# ADDENDUM NO. 2

**October 24, 2023**

**Bid Package No. 2 - LOWELL HIGH SCHOOL RENOVATIONS AND NEW SPORTS COMPLEX**
**Lowell, IN 46356**

TYPICAL ACCESSIBLE MOUNTING HEIGHTS, WALL TYPES, ABBREVATIONS, SYMBOLOGY, AND LEGEND

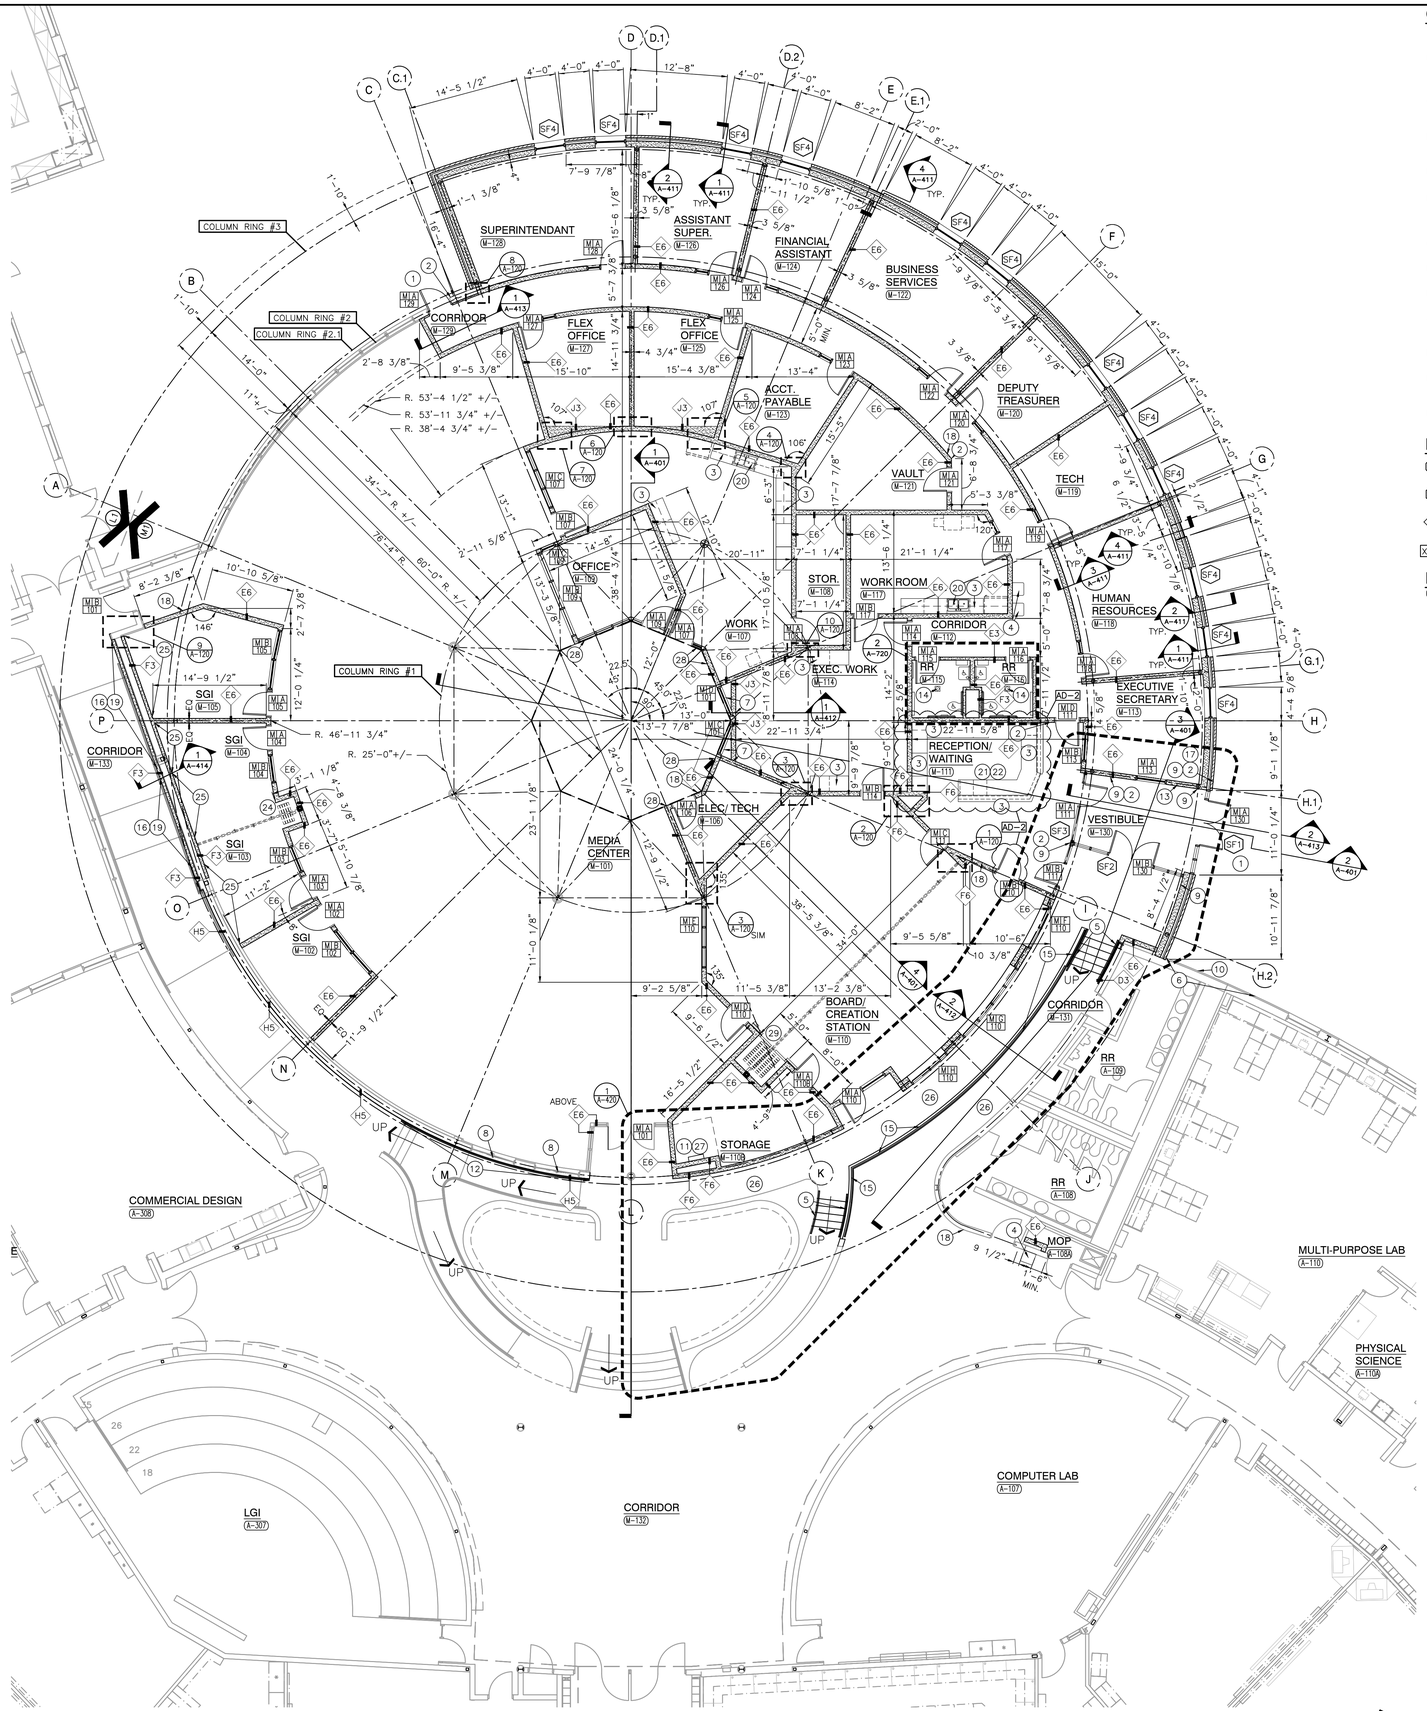
9. **Sheet G-301**
   A. Refer to revised full size drawing included in this Addendum for the following revisions.
      1. Add Partition Type "B4" as indicated.
      2. Revise Wall Types B6 and B8 as indicated.
10. **Sheet A-102-AD**
   A. Refer to revised full size drawing included in this Addendum for the following revisions.
      1. Revise M-111 Reception/ Waiting and door M-110B as Indicated.

5 A-411

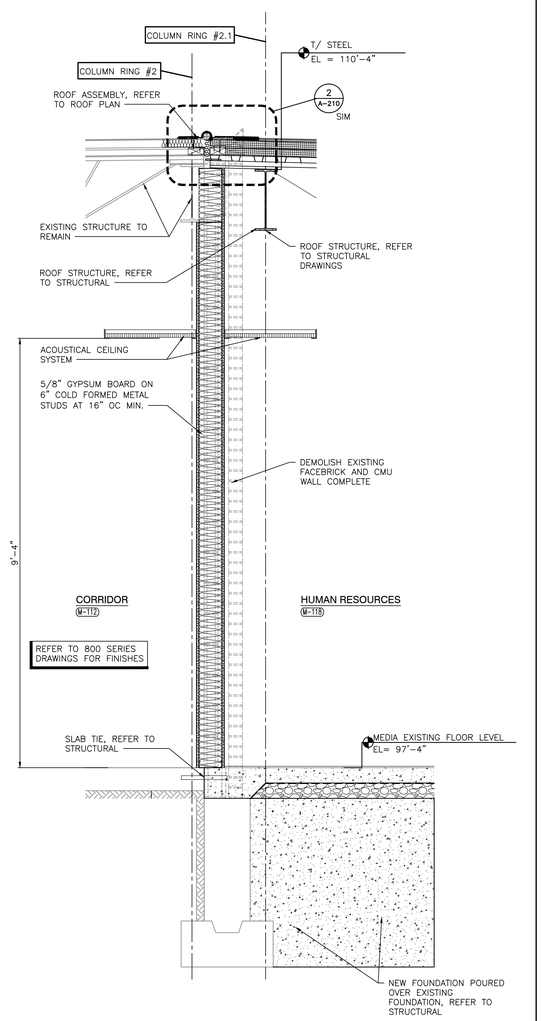
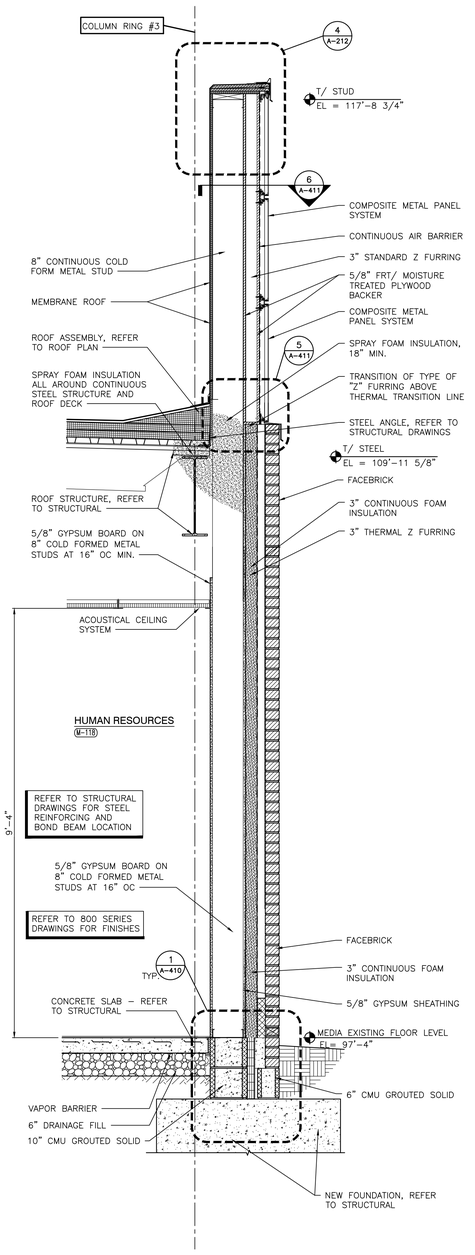
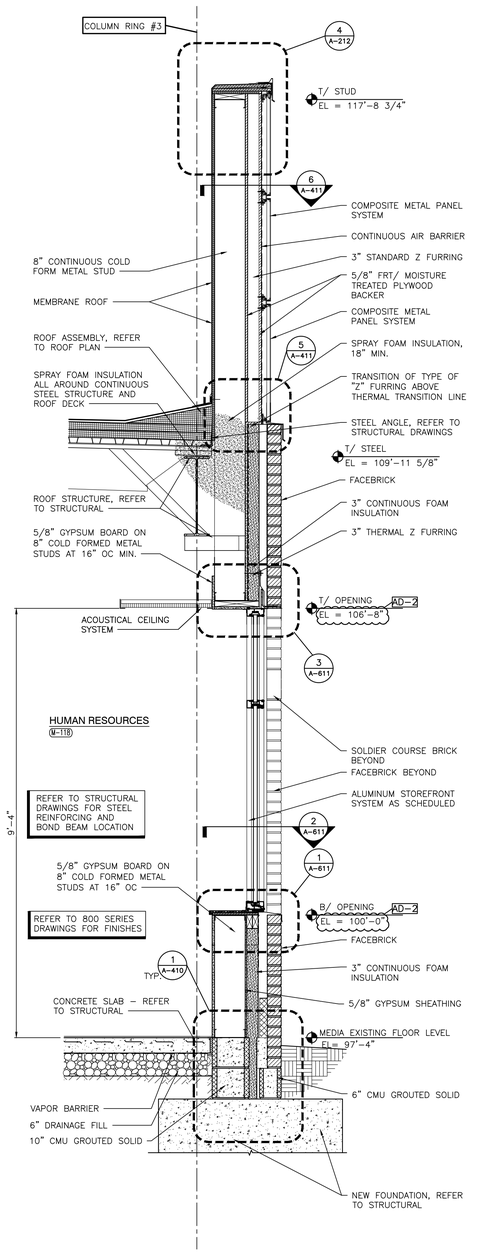
1. 1/A-411 Revise elevations at masonry openings as indicated.

2
A-412

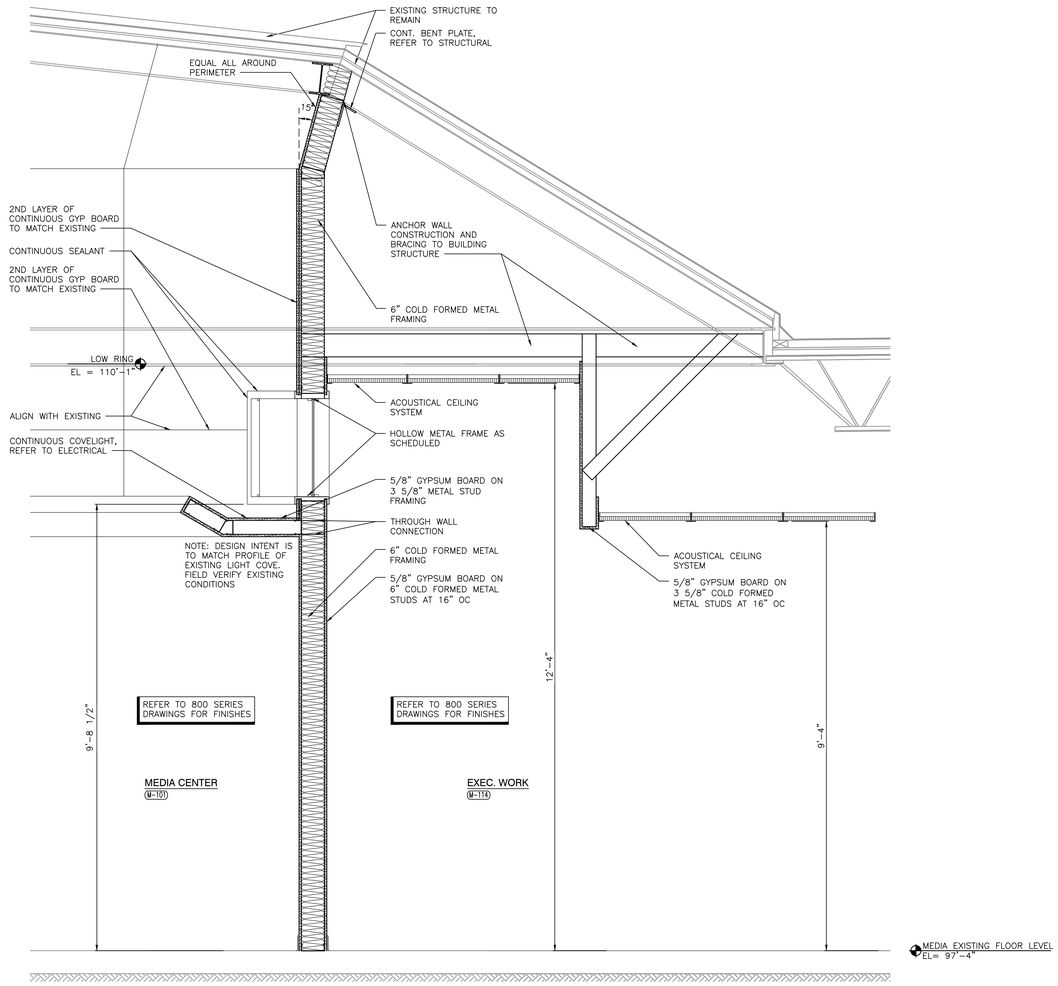
1. 2/A-412 Revise elevation as indicated.

ENLARGED STAIR SECTION
SCALE: 3/4" = 1'-0"
5 A-420

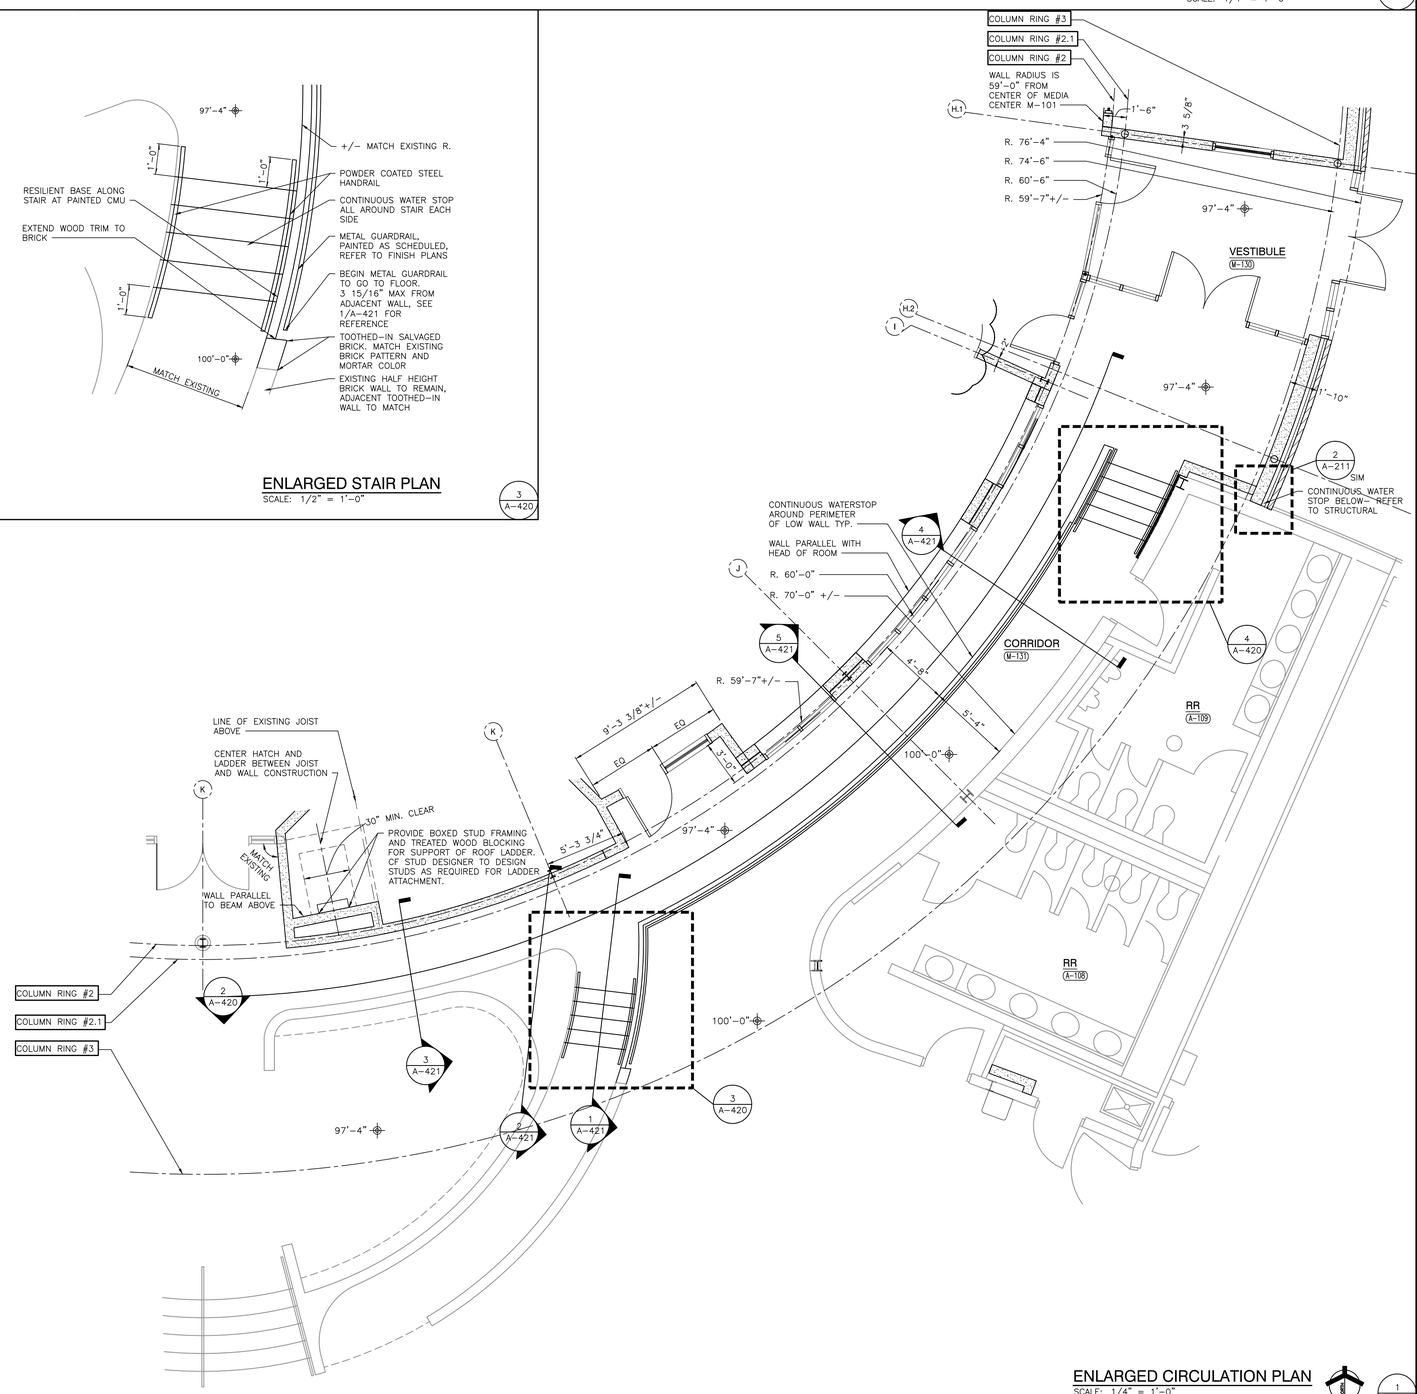
1. 5/A-420 Revise rail sleeve note as indicated.

3
A-421

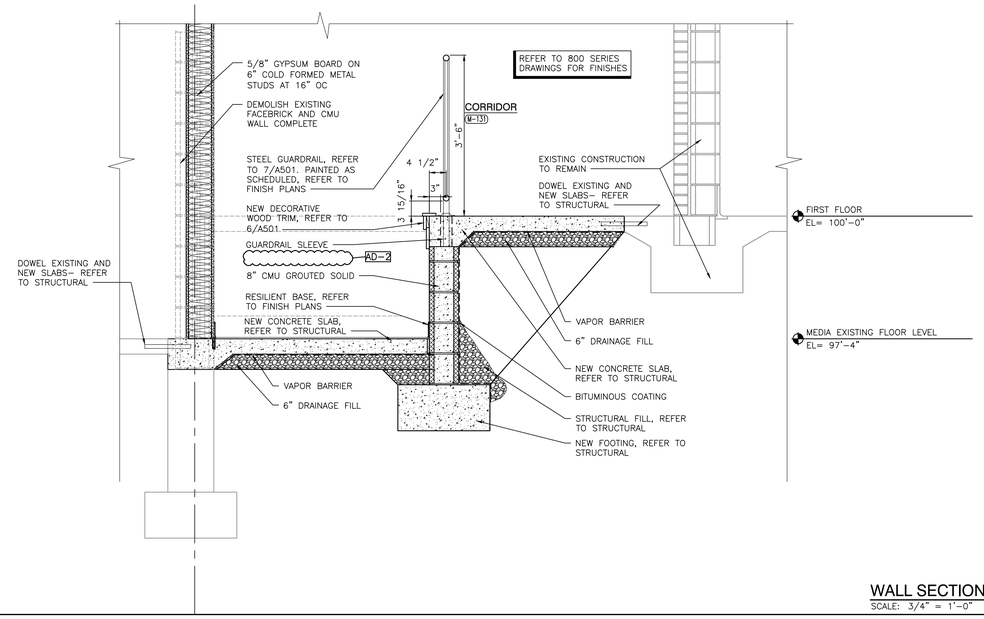
1. 3/A-421 New brick wall removed as indicated.
2. Revise rail sleeve notes as indicated.
